Title: Robertson Crossing Planned Unit Development (ZMA-16-22)

Staff: Kevin Lewis, Senior Planner

Date: January 19, 2023

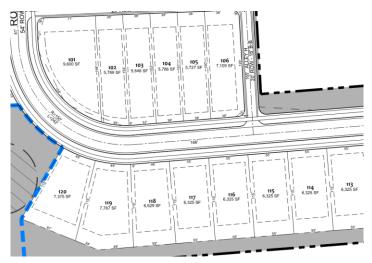
• **Requested**: Road R, as shown below, shall exceed the maximum length of 300-feet. The design of this road is otherwise consistent with all other UDO regulations and Fire Code requirements.

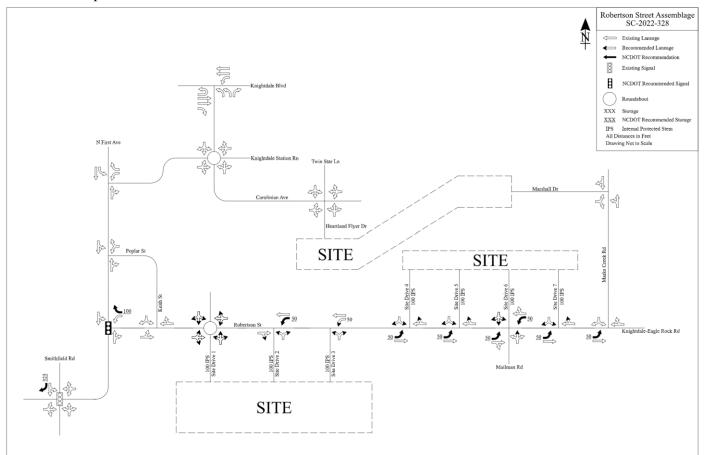
In addition to these recommended improvements, NCDOT recommends safety upgrades shown on the exhibit below. Items of note include multiple eastbound left turn lanes along Robertson Street entering the mixed-use parcel at the intersection of Mailman Road. Town Staff and NCDOT agree that reducing the number of driveways permitted at this site would eliminate the need for multiple turn lanes and reduce the potential for future conflict points between pedestrians and motorists.
